DARWIN LNG PLANT

Supplement to Draft Environmental Impact Statement

I.1 PURPOSE OF THIS DOCUMENT

Phillips Oil Company Australia
DARWIN LNG PLANT, DRAFT EIS, EXECUTIVE SUMMARY
MAJOR COMPONENTS

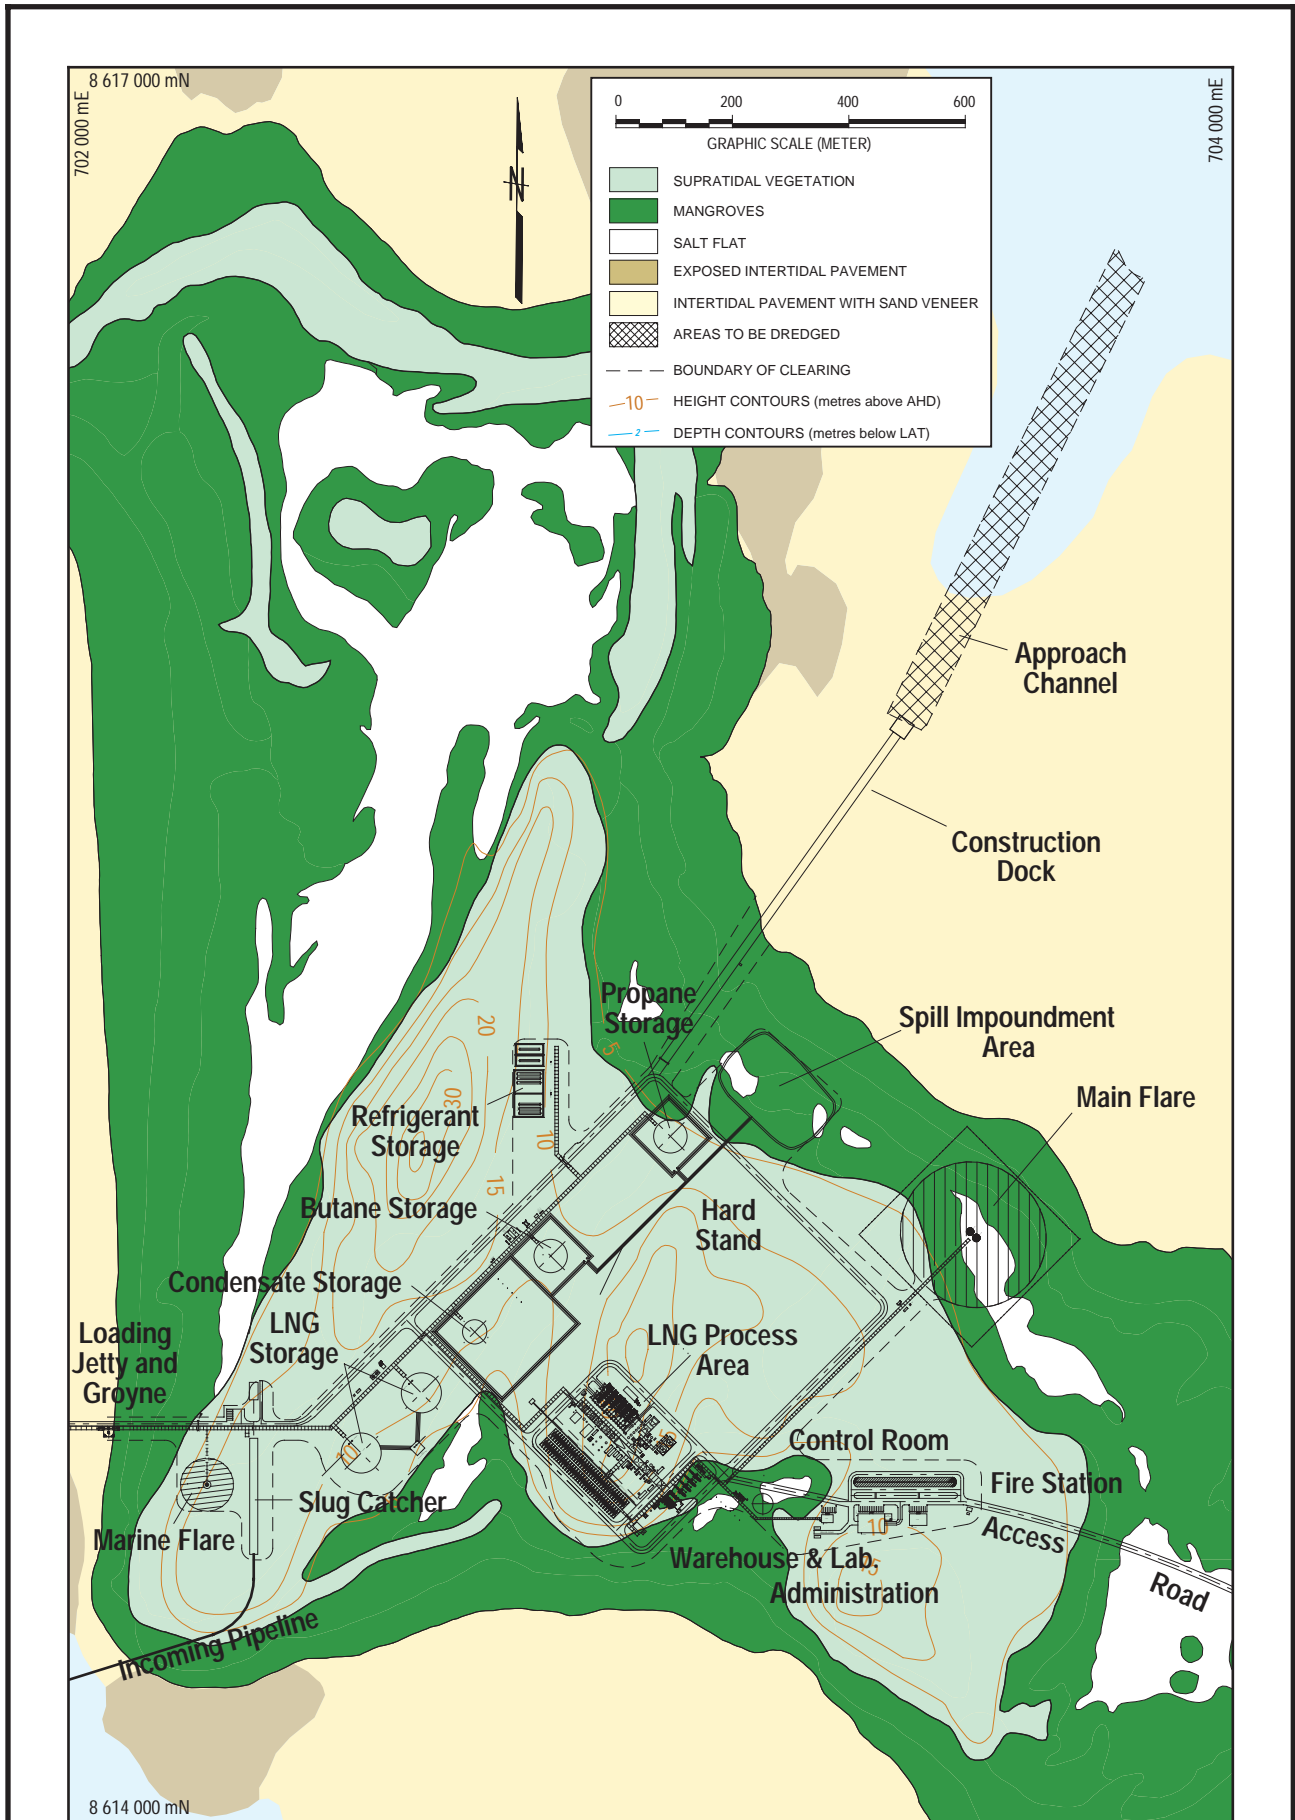
- (i) the re-design of the project footprint for both a 3 MTPA and 9 MTPA plant. The necessity to address the effect of a three train (9 MTPA) plant led Phillips to investigate the land area requirement, layout and method of construction for such a plant. As a result of additional studies, it was acknowledged that, by relocating the original 3 MTPA process train, future expansion to a 9 MTPA (three train) plant could be optimised. This has resulted in relocating the initial train to the south side of Wickham Point, thereby enabling gradual expansion to the north where the construction dock is located. This eliminates the possible need to build another construction dock on the south side of Wickham Point for future expansion.

Figure I.1 presents the new project development plan for the Wickham Point site. Comparison to Figure 1.3 of the Draft EIS reveals the following modifications:

As a result of the above modifications, the land area required for the three MTPA plant site has increased from 61 ha to approximately 68 ha. However, on the positive side, the new design:

- allows for fauna access corridors to be maintained on the south side of the plant by moving back from the mangroves and providing culverts beneath the landward end of the loading jetty;
- reduces the total area of Wickham Point required for a three train (9 MTPA) plant from 150 ha to approximately 100 ha (refer Appendix 4)

Stokes Hill Wharf - Distance From Site 7 km.

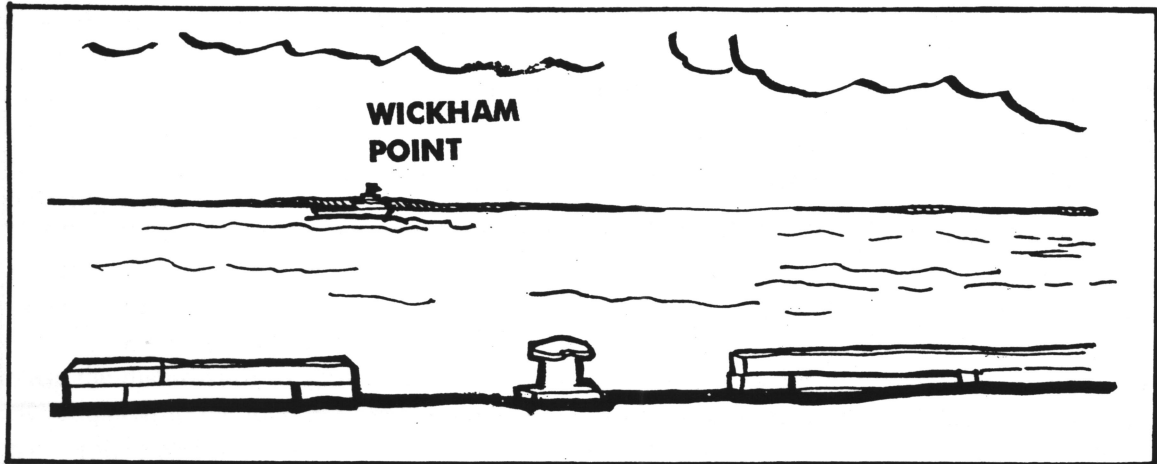
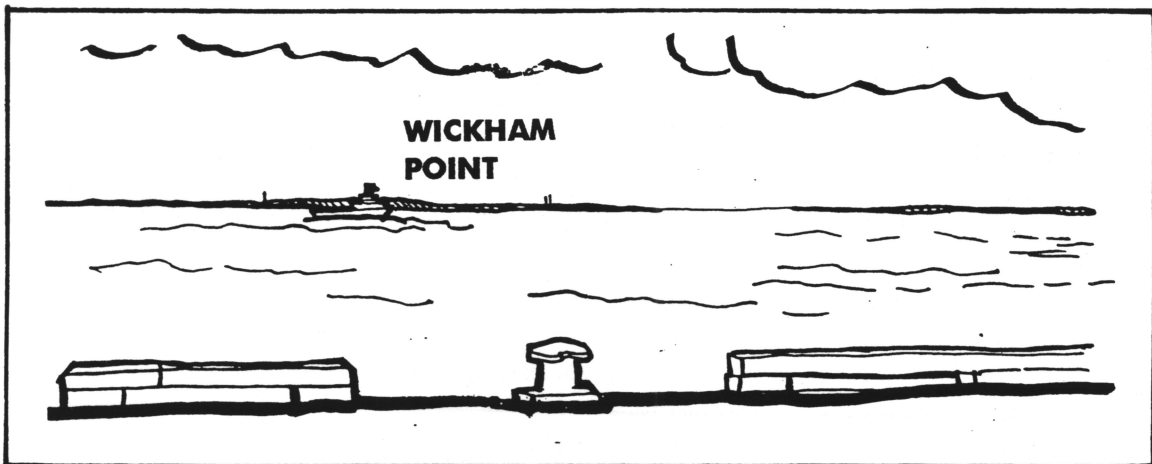
Several of the vantage point sketches included in Appendix O of the Draft EIS are reproduced on pages 51 and 52 for information. It should be noted that the sketches have not been amended to reflect the new plant layout shown in Figures I.1 and I.2. The overall visual impact as presented in the sketches will not be materially affected by the changes to plant layout, due to the distance from the vantage points to the plant site and the scale of the drawing.
